# SERVICE No. 991A BULLETIN

DATE: January 29, 1996

(Service Bulletin No. 991A supercedes and voids Service Bulletin No. 991 dated January 10, 1996)

**Replacement or Modification of the  
Alternator Out Light Fuse**

**PA-28-161 (CADET)**  
(Refer to the Maintenance Manual as necessary.)

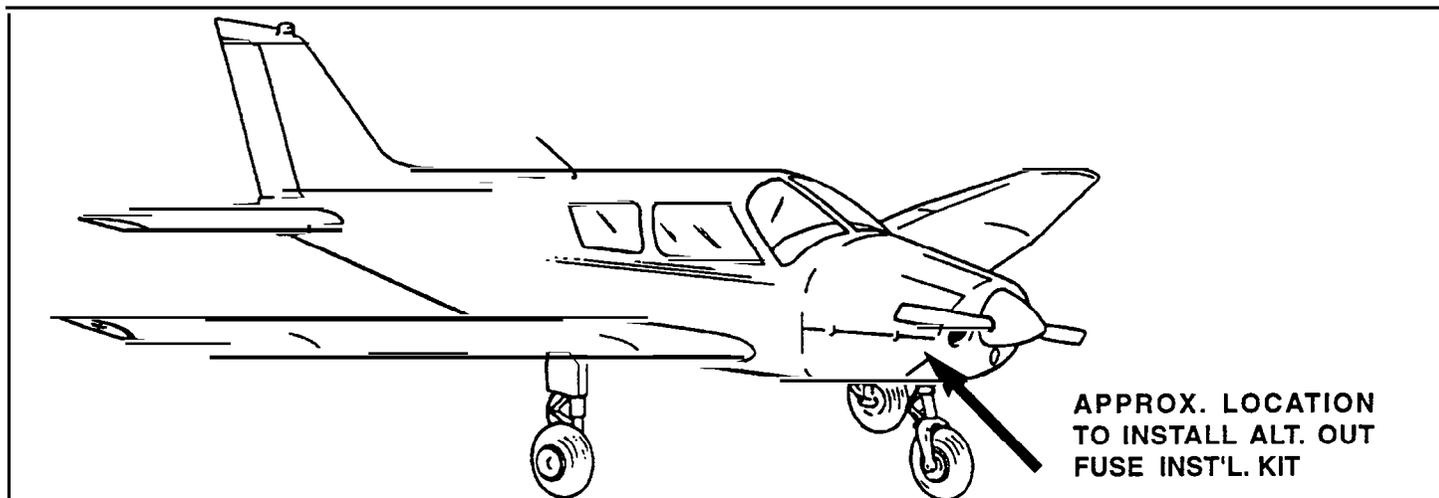
1. Remove the engine cowling.
2. Locate the alternator AUX terminal.
3. Remove the existing wire from the alternator AUX terminal and install the Alt Out Fuse Installation Kit Piper Part Number 766-293 per kit instruction.
4. Secure the fuse holder with a Ty-rap.
5. Perform run up and functional check.
6. Reinstall the engine cowling.

**PA-28R-201 (ARROW)  
PA-28R-201T (TURBO ARROW)**

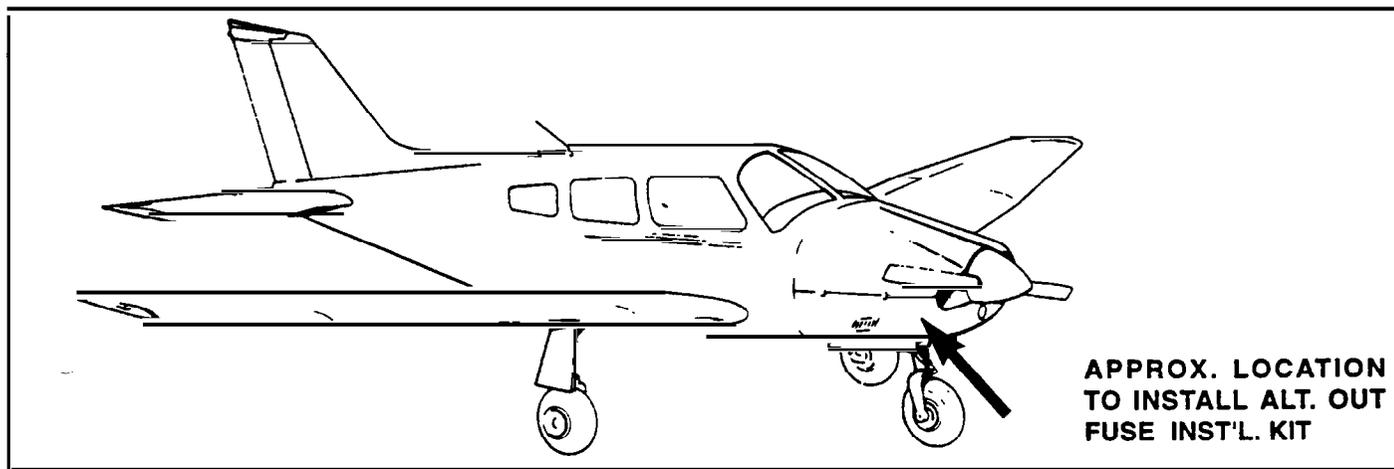
1. Remove the engine cowling. (Arrow shown as typical.)
2. Locate the alternator AUX terminal.
3. Remove the existing wire from the alternator AUX terminal and install the Alt Out Fuse Installation Kit Piper Part Number 766-293 per kit instruction.
4. Secure the fuse holder with a Ty-rap.
5. Perform run up and functional check.
6. Reinstall the engine cowling.

**PA-38-112 (TOMAHAWK)**

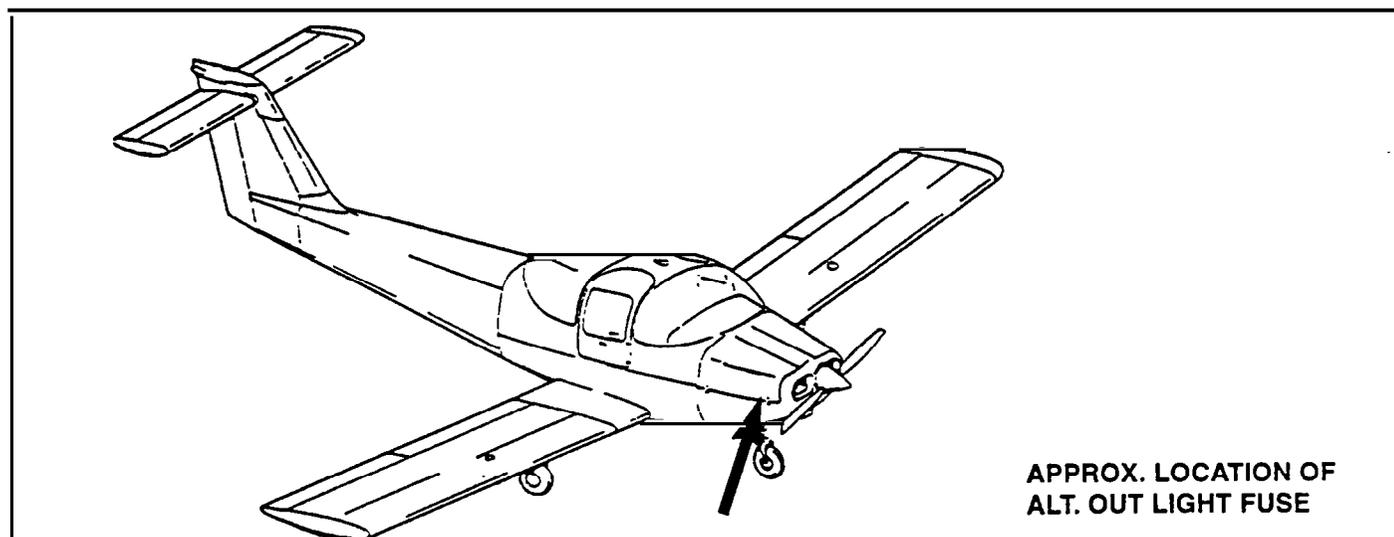
1. Remove the engine cowling to gain access to the alternator.
2. Locate the alternator AUX terminal and follow the wiring to the fuse holder between wire (WIC20) and (WID20).
3. Remove the existing fuse and install new fuse part number 461-643. *NOTE: Inspect condition of the existing fuse holder and replace as required.*
4. Perform run-up and functional check.
5. Reinstall the cowlings.

**PA-31, 31-325 (NAVAJO, NAVAJO C/R)  
PA-31-350 (CHIEFTAIN & T1020)  
PA-31P (PRESSURIZED NAVAJO)**

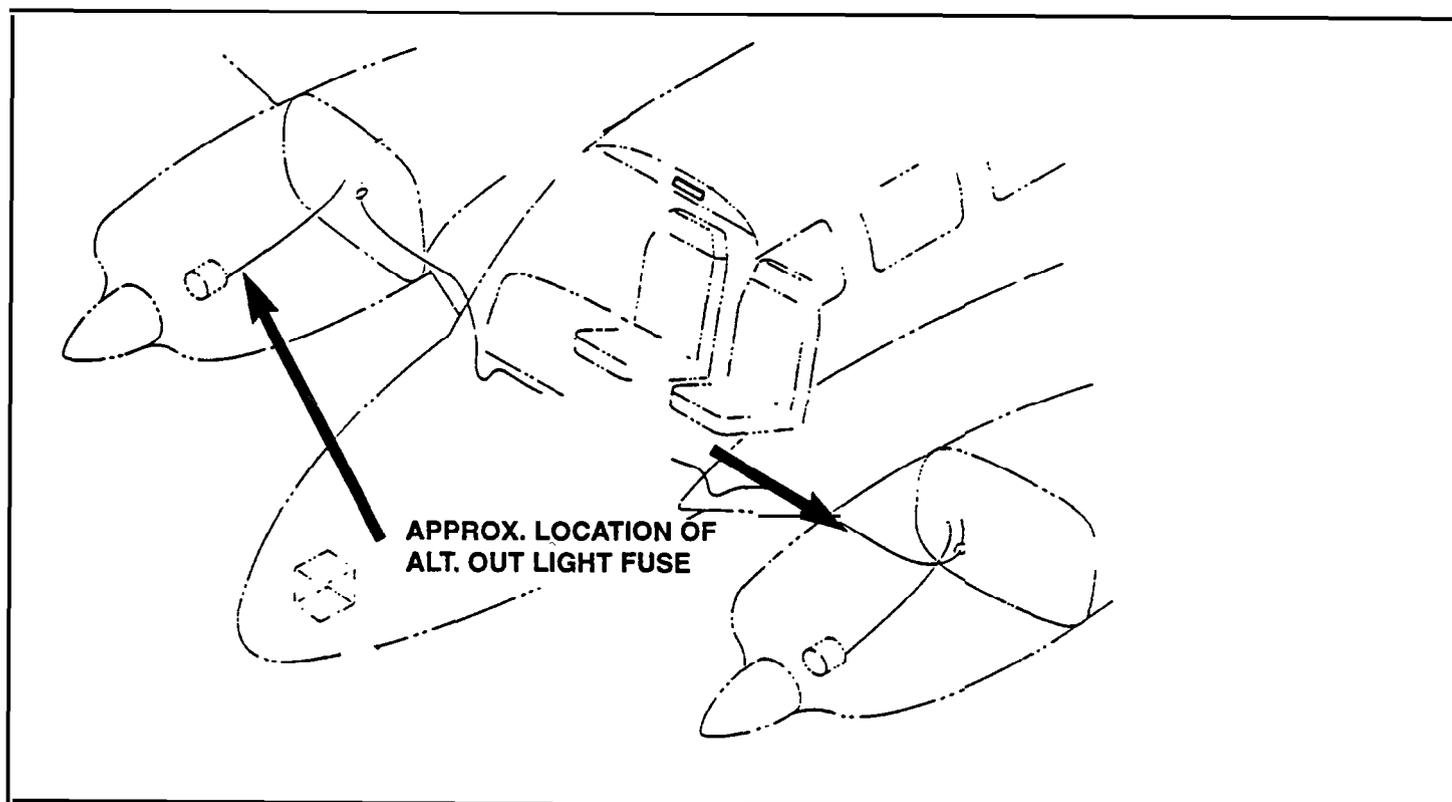
1. Remove the upper and lower engine cowlings to gain access to the alternators.
2. Locate the alternator AUX wire on the left and the right alternator.
3. Follow the wire to the fuse holder.
4. Remove the existing fuse and install fuse part number 461-643, secure wires and fuse holders after installation. *NOTE: Inspect condition of the existing fuse holder and replace as required.*
5. Perform run-up and functional check.
6. Reinstall the cowlings.
